BEAVER VALLEY POWER STATION, UNIT NO. 1

Amendment No. 80  
License No. DPR-66

AMENDMENT NO. 80 TO FACILITY OPERATING LICENSE NO. DPR-66

SAFETY EVALUATION BY THE OFFICE OF NUCLEAR REACTOR REGULATION  
RELATED TO AMENDMENT NO. 80 TO FACILITY OPERATING LICENSE NO. DPR-66

BEAVER VALLEY - UNIT 1  
FIGURE 5.1-1  
5-1b

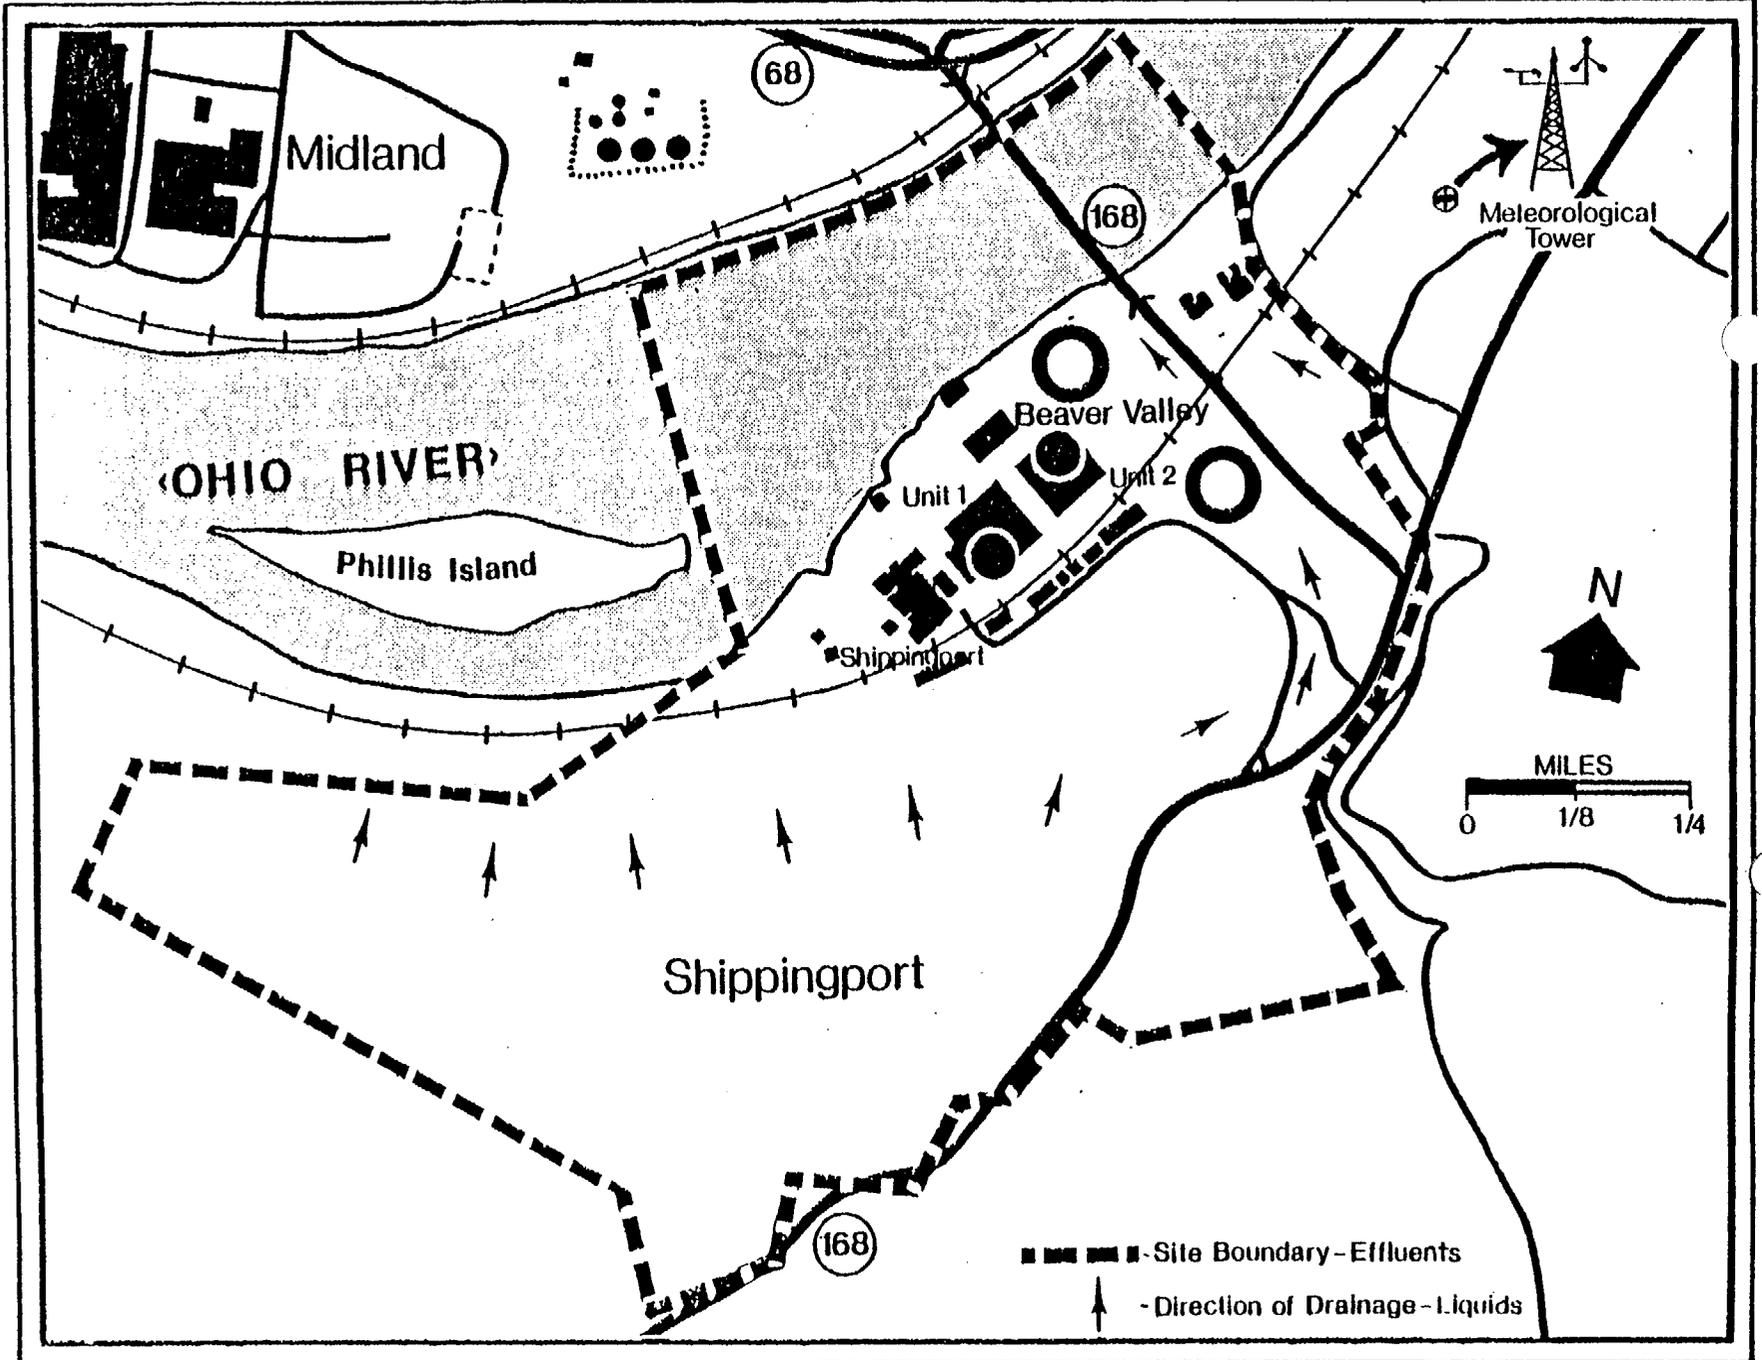
The licensee also requested a number of changes to the Technical Specifications to correct administrative errors due to previous amendments. These corrections are all acceptable and are issued as amended Pages 3/4 3-56, 3/4 7-14 and 5-1b of the Technical Specifications.
